ADA Curb Ramp New Construction Inspection Form (Parallel)

Nw. Glencoe rd.

24952.54

Nw pacific st.

PARALLEL RAMP (PL)

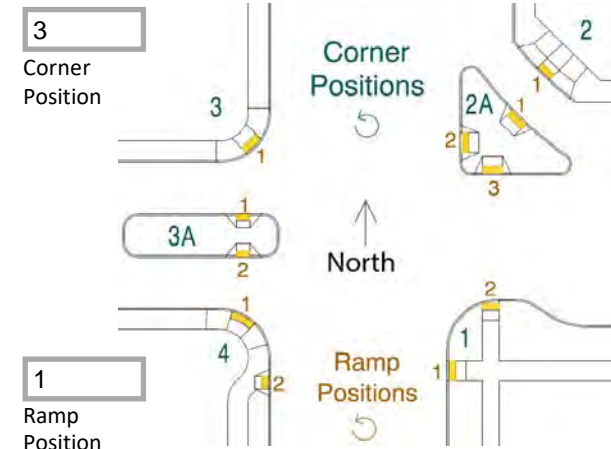
2.5 $\leq 2.0\%$ ☐ $> 2.0\%$ ☒

2.5 $\leq 2.0\%$ ☐ $> 2.0\%$ ☒

IITD, cut domes in center of ramp.
